APPLICATION FOR SOIL INVESTIGATION

SITE EVALUATION

S.I.R. NO. 21571

RE: Property located at Ira Flow Road, Lot 4

**See Diagram on Back (includes: soil areas, property lines, roads, streams, gullies, wet areas, fill areas, wells, water bodies, slopes)

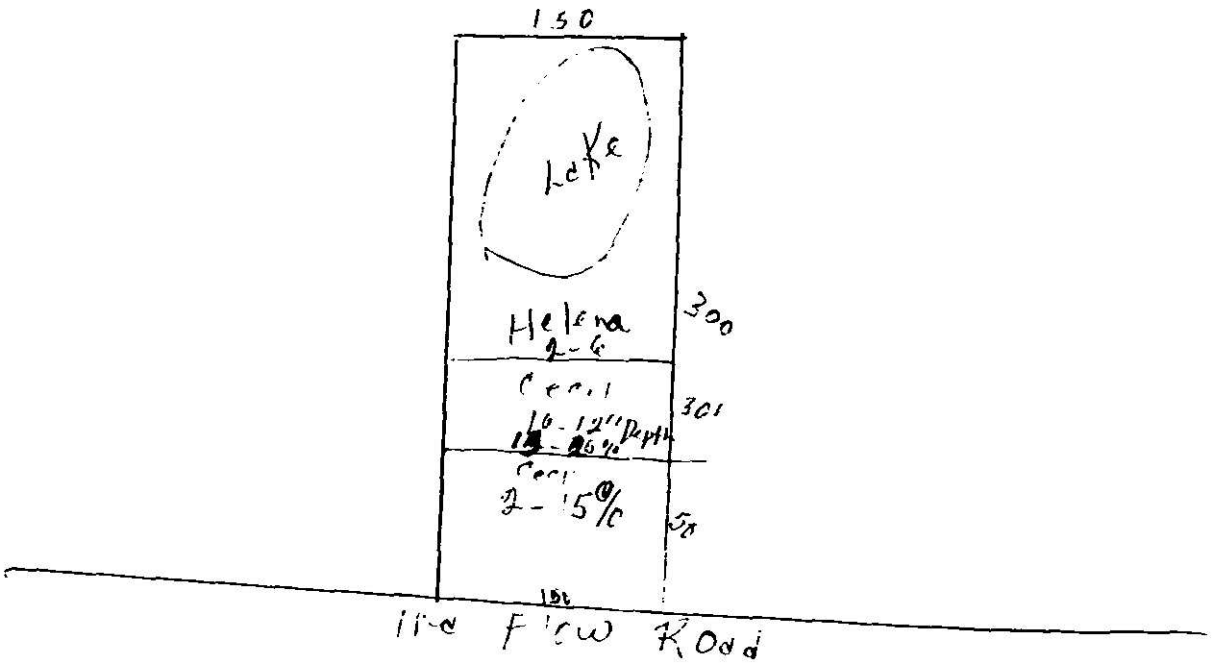
Recommendations/Comments: Pump [illegible] Required To Use The F.S. Area

150
Lake
Helena
2-6
300
Cecil
10-12" Depth
301
Cecil
2-15%
50
150
Flow Road
